Multi-span Roof in FprEN 1991-1-3: 2023, 7.5.4

Summary of the comments

Fig. 1: Shape Coefficient and Snow Load Level FprEN 1991-1-3: 2023, 7.5.4, Case (i) - Inconsistence

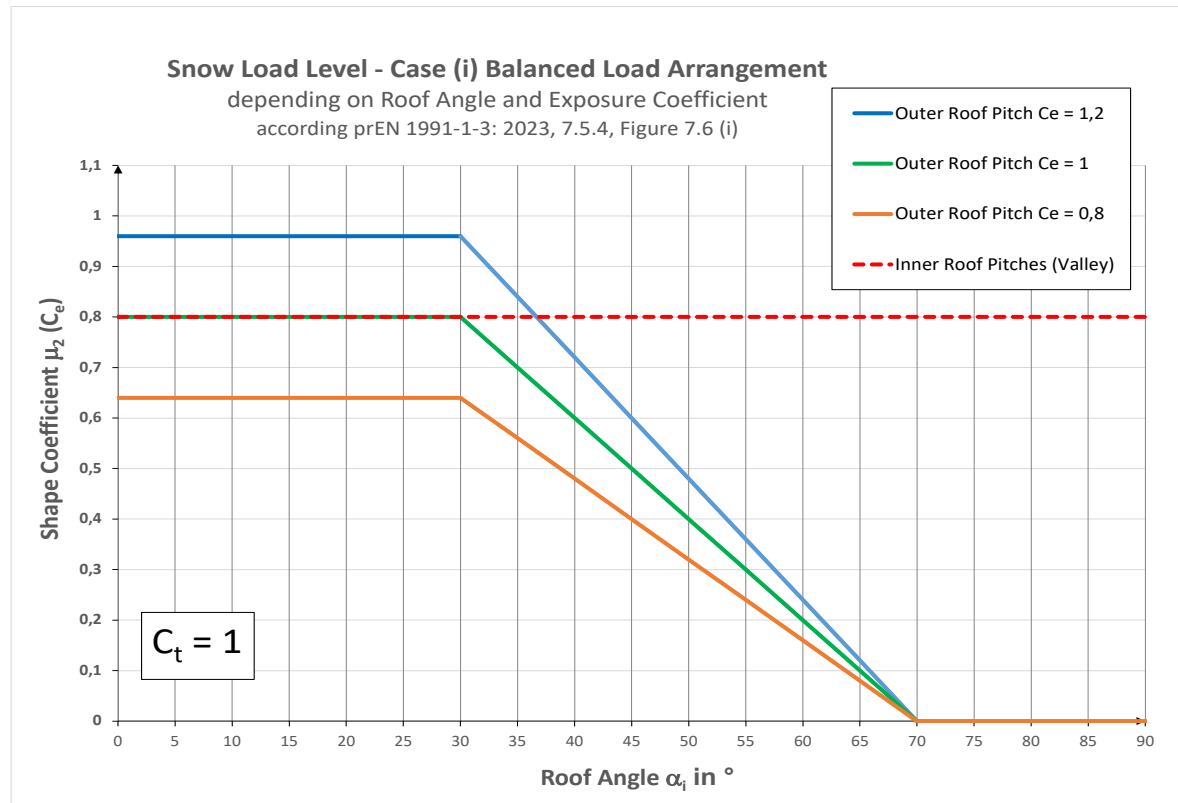
No.	Existing text	Comment	Proposed action + corrected text																																			
5 (i)	(1) The balanced load arrangement that should be used for multi-span roofs is shown in Figure 7.6 case (i), the snow load shape coefficient $\mu_2(\alpha, C_e)$ being given by Formula (7.7) for case (i).	<p>The calculation of the snow load distribution for Figure (7.6), case (i) does not match the representation of the snow load distribution in Figure (7.6). The shape coefficient $\mu_2(30^\circ, \mathbf{1})$ for the roof valley is inconsistent.</p> <p>Wat was the intention of $C_e = \mathbf{1}$? A reduction of the drift losses out of the valley in comparison to drift losses from a flat roof??? If this is the case, this regulation does NOT suffice, as shown in Fig. 1.</p>

<p style="text-align: center;"><i>Note</i> *: Also, for $\alpha > 30^\circ$ the regulation can also be <i>formally correct</i>, see also Fig. 1.</p> <p style="text-align: center;">Table 1: Inconsistency prEN 1991-1-3: 2023, 7.5.4, case (i)</p> <p>If the drift losses from the valley are to be reduced in comparison to a flat roof, the evenly distributed snow depth there should be larger than on the outer pitch with usual conditions for pitched roofs. Therefore, a special value $C_{e,T}$ for the valley, adapted to C_e, should be defined.</p> <p>Drift surcharges or losses should always be a National Choice.</p>	For roof angles $\alpha \leq 30^\circ$					According to FprEN 1991-1-23; 2023, 7.5.4 (1): with reference to Case (i), Formula (7.7)					Exposure Coefficient C_e	Shape Coefficient Outer Pitches $\alpha \leq 30^\circ$ (windward, leeward) Figure 7.6 (i)		Shape Coefficient Valley Inner Roof Pitches Figure 7.6 (i)	Comparison	Table 7.1 (NDP)	Formula (7.7), Case (i)		Figure 7.6, Case (i)		$C_e = 1,2$	$\mu_{2,b} = 0,8 C_e^* = \mathbf{0,96}$	$>$	$\mu_2(30^\circ, \mathbf{1}) = \mathbf{0,8}$	wrong	$C_e = 1$	$\mu_{2,b} = 0,8 C_e^* = \mathbf{0,8}$	$=$	$\mu_2(30^\circ, \mathbf{1}) = \mathbf{0,8}$	Not intended	$C_e = 0,8$	$\mu_{2,b} = 0,8 C_e^* = \mathbf{0,64}$	$<$	$\mu_2(30^\circ, \mathbf{1}) = \mathbf{0,8}$	Formally correct	<p><i>In Figure (7.6), case (i):</i> <i>Replace:</i> $\mu_2(30^\circ, \mathbf{1})$ <i>by:</i> $\mu_2(30^\circ, C_{e,T})$</p> <p><i>Add a note in Paragraph (1):</i> NOTE The exposure coefficient for the valley (trough) of the multi-span roof $C_{e,T}$ is $(1,25 + C_e)/2$, unless the National Annex gives a different value.</p> <p>Alternatively, the worst case could be set as a standard, to encourage National regulations:</p> <p><i>Add a note in Paragraph (1):</i> NOTE The exposure coefficient for the valley (trough) of the multi-span roof is $C_{e,T} = \mathbf{1,25}$, unless the National Annex gives a different value.</p>
For roof angles $\alpha \leq 30^\circ$																																						
According to FprEN 1991-1-23; 2023, 7.5.4 (1): with reference to Case (i), Formula (7.7)																																						
Exposure Coefficient C_e	Shape Coefficient Outer Pitches $\alpha \leq 30^\circ$ (windward, leeward) Figure 7.6 (i)		Shape Coefficient Valley Inner Roof Pitches Figure 7.6 (i)	Comparison																																		
Table 7.1 (NDP)	Formula (7.7), Case (i)		Figure 7.6, Case (i)																																			
$C_e = 1,2$	$\mu_{2,b} = 0,8 C_e^* = \mathbf{0,96}$	$>$	$\mu_2(30^\circ, \mathbf{1}) = \mathbf{0,8}$	wrong																																		
$C_e = 1$	$\mu_{2,b} = 0,8 C_e^* = \mathbf{0,8}$	$=$	$\mu_2(30^\circ, \mathbf{1}) = \mathbf{0,8}$	Not intended																																		
$C_e = 0,8$	$\mu_{2,b} = 0,8 C_e^* = \mathbf{0,64}$	$<$	$\mu_2(30^\circ, \mathbf{1}) = \mathbf{0,8}$	Formally correct

Note: ISO 4355: 2013, ASCE 7-16 or NBCC 2015 do not reduce the drift losses for the balanced load case (case (i) in FprEN 19991-1-3: 2023), only for the unbalanced load case (case (ii))!!!
 In this case for case (i) $C_{e,T} = C_e$ applies.

Fig. 2: Roof Snow Load Distribution (snow depts on a Multi-span Roof in the Bavarian Alps)

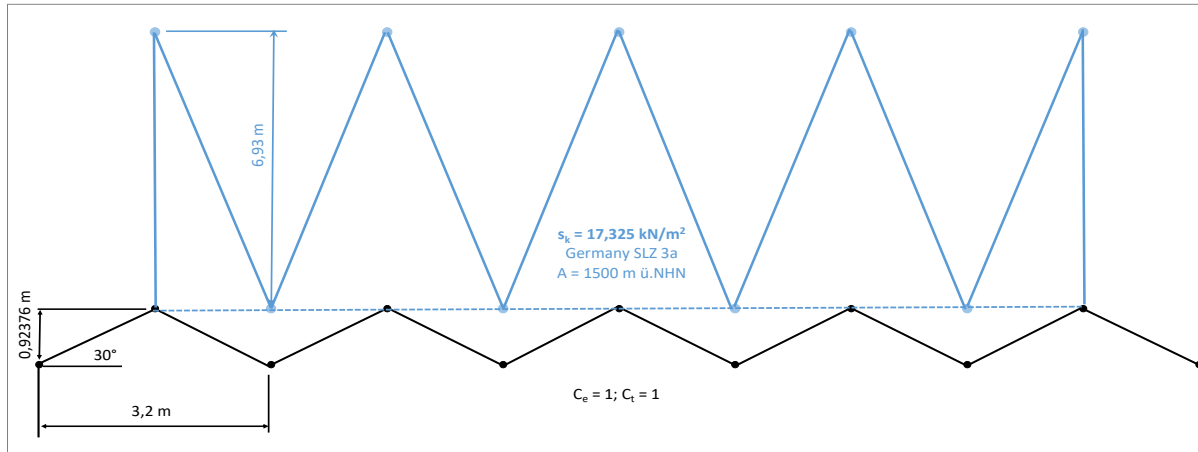
The “hard” limit at ridge level h for μ_3 ($d = s_3 / \gamma \leq h$) for the maximum snow height in the valley, independently from μ_2 for the snow above the ridges, can lead to large mounts above the ridges, in case the snow height s_2 / γ is much larger than the height of the valley, see **Fig. 2**.

A distribution as in **Fig. 2** does not agree with the wind field above multi-span roofs, which tends to level out any snow surface above the ridges, as on a flat roof. Also, measurements (**Ottawa, 1971**) as well as the tests in **the Climatic Wind Channel Jules Verne, Nantes, France** are evidence against such a distribution.

Fig. 3: Ratio of Roof to Ground Snow Load depending on the Snow Load (too large for small snow loads, too small for large snow loads - reliability?)

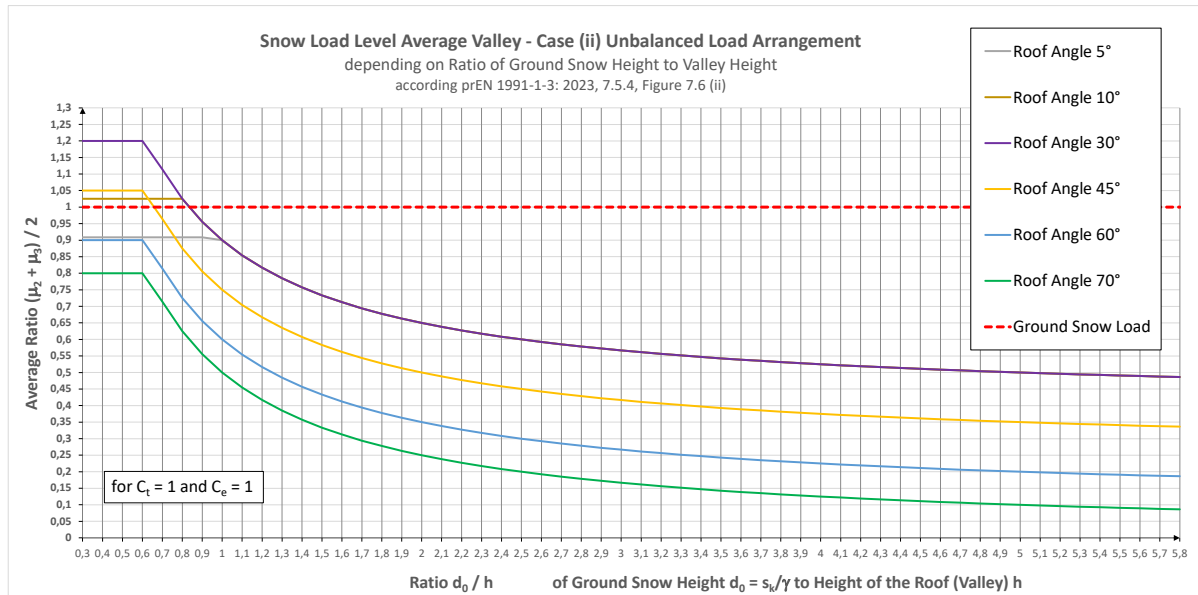
On the other hand, the total snow load in the valley $S_T = \sum s_i / (C_t \cdot s_k) = (\mu_2 + \mu_3)/2$ will be reduced with an increasing ratio of ground snow height s_k/γ to valley height h , see **Fig. 3**. For 30° , for a ratio of 5, the total roof snow load will be down to 50% of the ground snow load. Such trends are not acceptable.

The model according to FprEN 1991-1-3: 2023 fails for large snow loads.

Fig. 4: Ratio of Roof to Ground Snow Load in the Valley depending on C_e and α

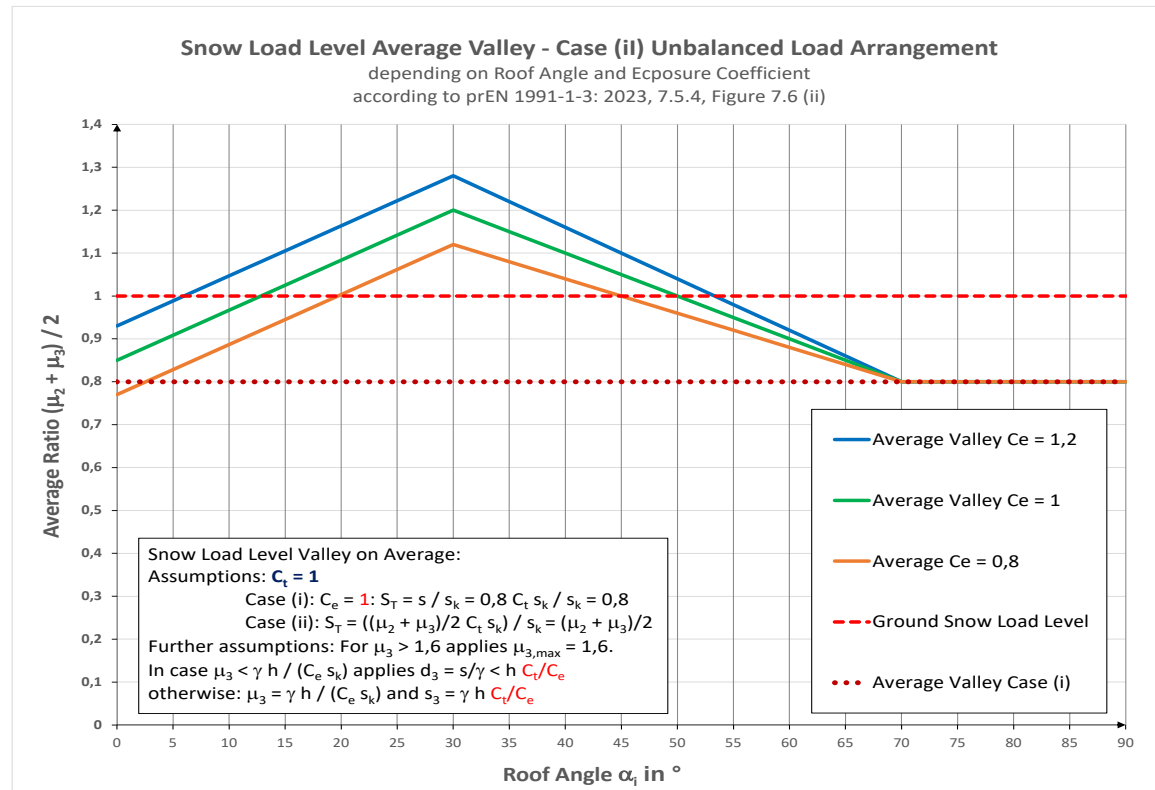
For small snow loads, where the “hard” limit cannot be reached, despite the “soft” limit at $\mu_{3,max} = 1,6$, the total snow load in the valley can become too large. The trends are shown in **Fig.4**.

Further calculation see Proposal of Figure 6 and Table 4.

Fig. 5: Roof snow load distribution (snow height in m) in comparison to the ground snow heights on a multi-span roof Ottawa 1971 according to **Taylor (1980)**

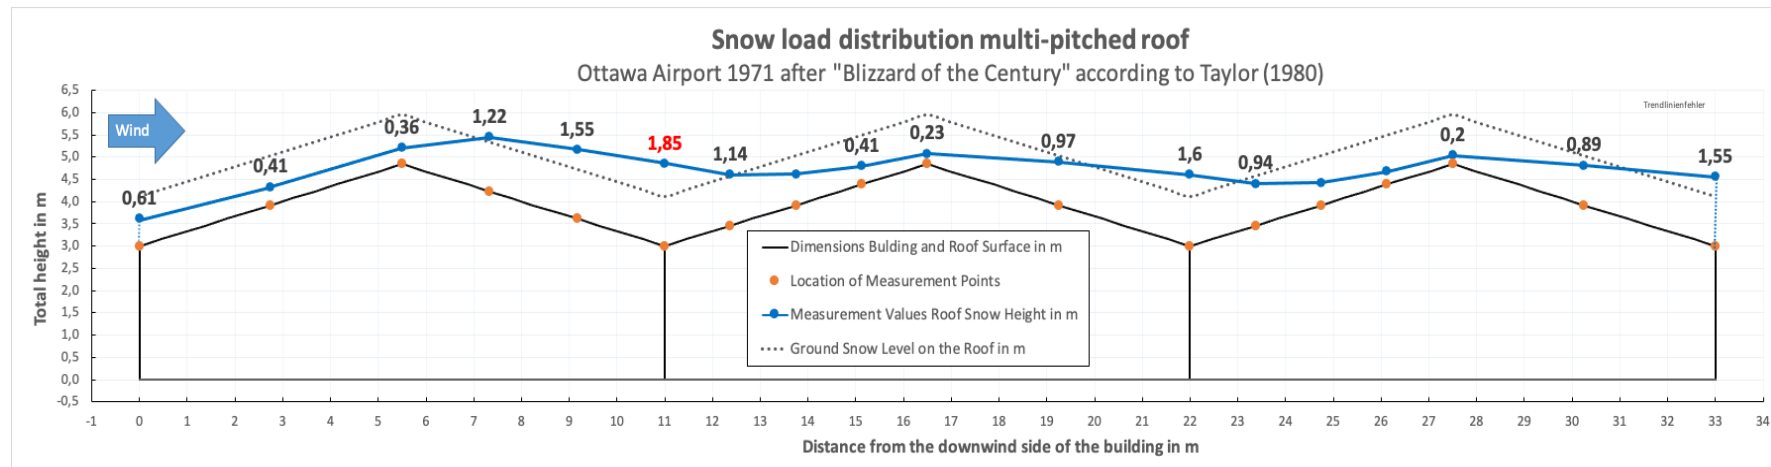
“The multi-span roof had 3 spans of 11 m each and a roof height of 1,83 m between eaves and ridges. The eaves height was small with 3 m above ground. The roof angle of this building was also very low with 18,4°, giving a ridges height of 4,83 m. With these dimensions the building remained within the ground snow drift zone of up to 5 m according to **Tabler (2003)**.” More details and comparisons can be found in **Pertermann & Puthli (2023)**.

“The rather exposed airport location may also have provided fetch distances of 150 m to 300 m to develop a saturated drift flow (**Takeuchi (1980)**). The blizzard lasted for 3 days. The snow load measured 3 kN/m² at the end. Therefore, the drift conditions (wind, snow, duration) were extreme for roofs of normal buildings.”

“It is important to understand, that the snow was not “redistributed” by wind after it accumulated, as often claimed, the drifting snow settled there at the first place due to the prevailing wind field saturated with drifting snow. More snow settled down in areas with lower wind speed, changing the wind field in such a way, that the wind could flow with less resistance over the obstacle. **Drifting is a self-regulatory process.**”

Fig. 6: Snow Load Distribution Multi-Span Roof: Unbalanced Snow Load Arrangement for Eurocode - case (ii)

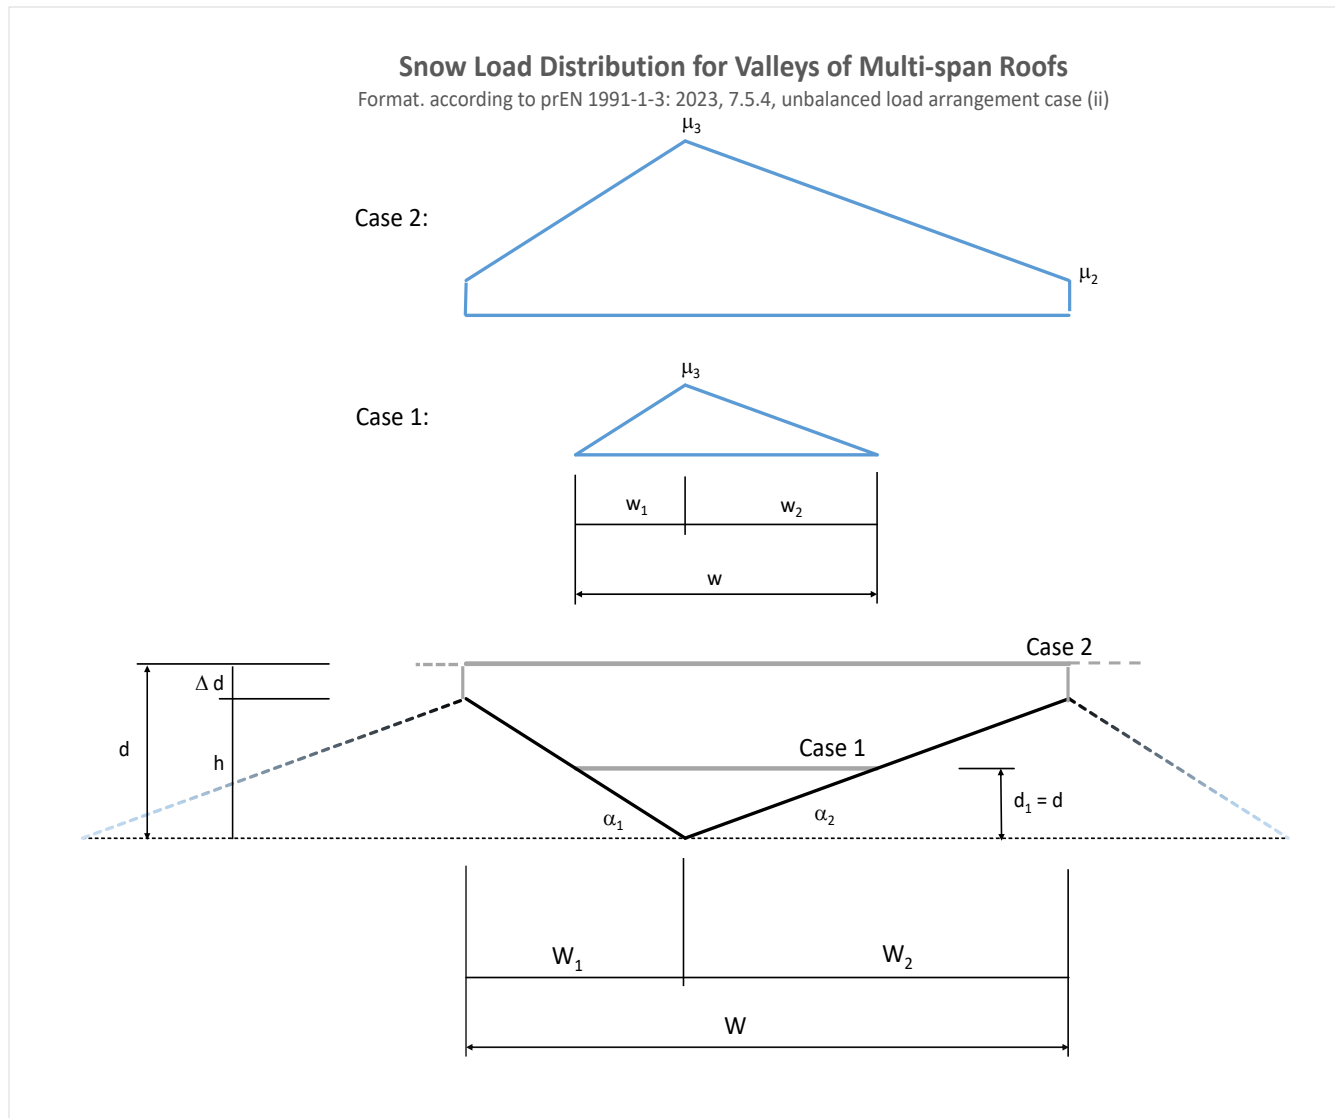
The model cannot be corrected for the shape coefficient μ_3 in the valley alone or by applying more limits. The shape coefficient for the ridge μ_2 needs to be changed depending on μ_3 . The volume of the valley needs to be calculated!!!

The model should be revised. In the consistent proposal the “hard” limit and the “soft” limit at 1,6 will be replaced by a test required for the estimation of the snow load distribution (case 1 or 2):

For a **consistent model** for the unbalanced **Load Case (ii)** for large and small valleys and for large and small snow loads, two cases need to be separated, **Case 1** and **Case 2**. Which case applies can only be found out by checking. For the test, in the first step, it is assumed the snow volume is smaller than the volume of the valley. The snow height of the assumed triangular distribution $d_1 = (1,6 h \cdot C_{e,T} \cdot C_t \cdot s_k / \gamma)^{1/2}$ is calculated and compared with the height of the valley h . The further calculation is given in **Table 4**.

Note: The drift potential (surcharge) in the valley can be varied (per **NDP**) using a special exposure coefficient $C_{e,T} > C_e$. With $C_{e,T} = C_{e,F} = 1,25$ the ground snow level can be reached. In case a drift surcharge of 120% is anticipated, $C_{e,T} = 1,5$ can be chosen. Allowing drift losses perpendicular to the main wind direction leads to $C_{e,T} = (1,25 + C_e)/2$, calibrated to measurement values. However, this a **National Choice**, the same as for flat and saddle roofs (C_e and d).
